SUMMARY OF PROPOSED CORRECTIVE ACTION MEASURE(S)

NAME OF FACILITY: Grumman - Naval Weapons Industrial Reserve Plant (NWIRP)

Date: April 26, 1995

COMMENTS AND NAVY RESPONSES
ON
PROPOSED REMEDIAL ACTION PLAN - SITES 1, 2, 3
NWIRP BETHPAGE, NY

FIGURE 11

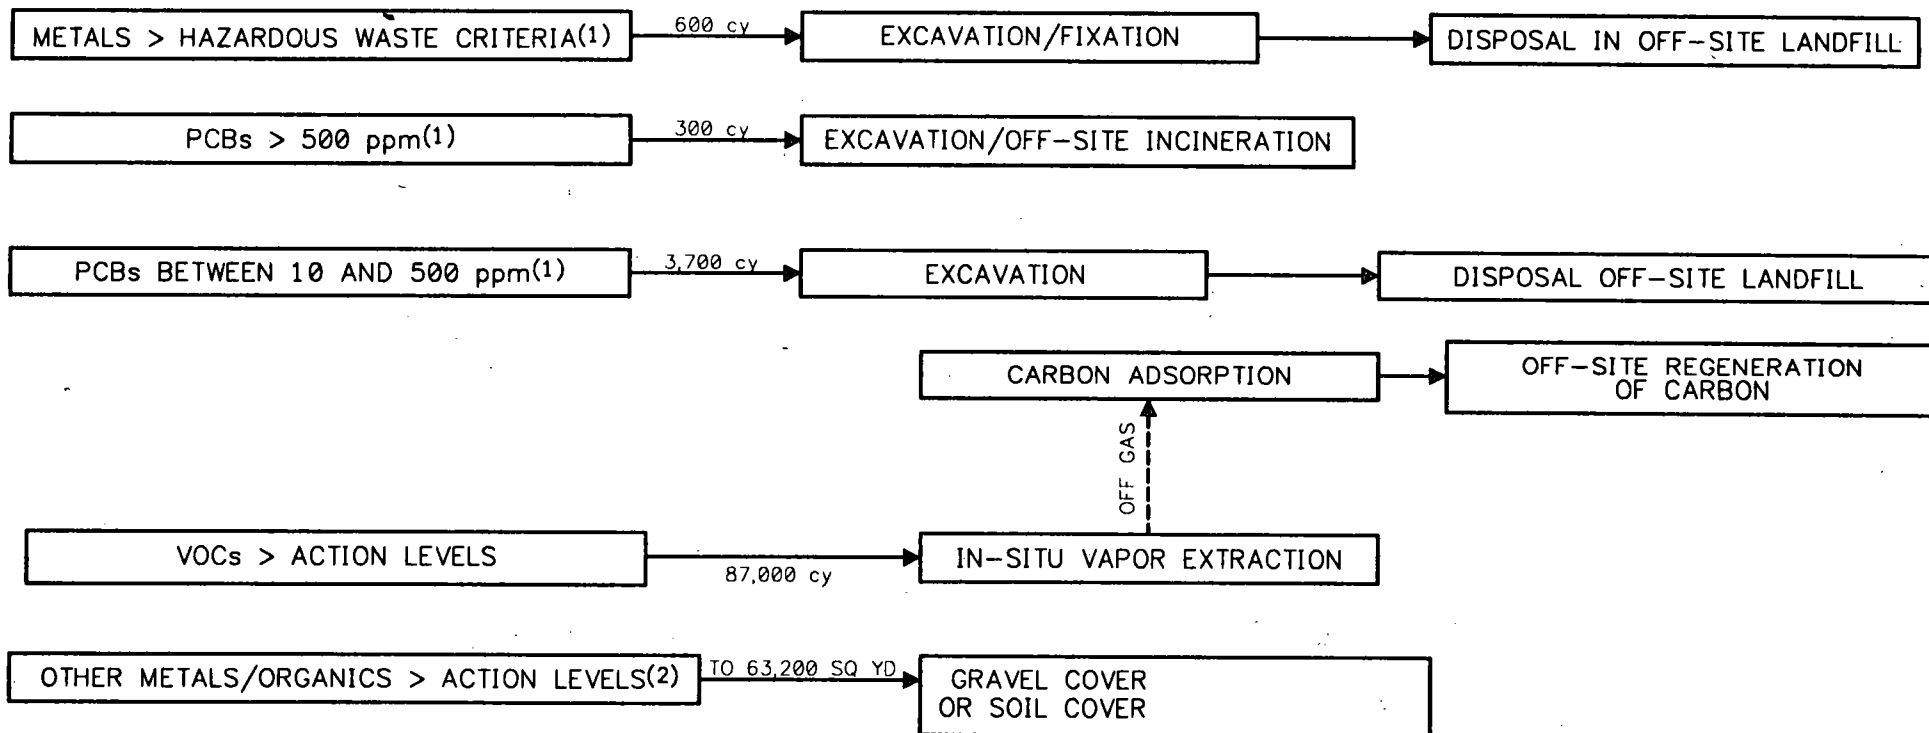
Decisions regarding the potential extent of metals excavation should not be based on TCLP criteria as is indicated on Figure 11 (see also page 28). More sophisticated modelling regarding metals fate and transport and the potential leaching of residual metals contamination based on soil concentrations levels should be conducted and used to determine appropriate action levels (if existing action levels based on current policy will not be used). The TCLP procedure is designed to determine whether something is a hazardous waste and it is not an acceptable means of determining potential leachability in the field (in order to establish soil excavation action levels)!
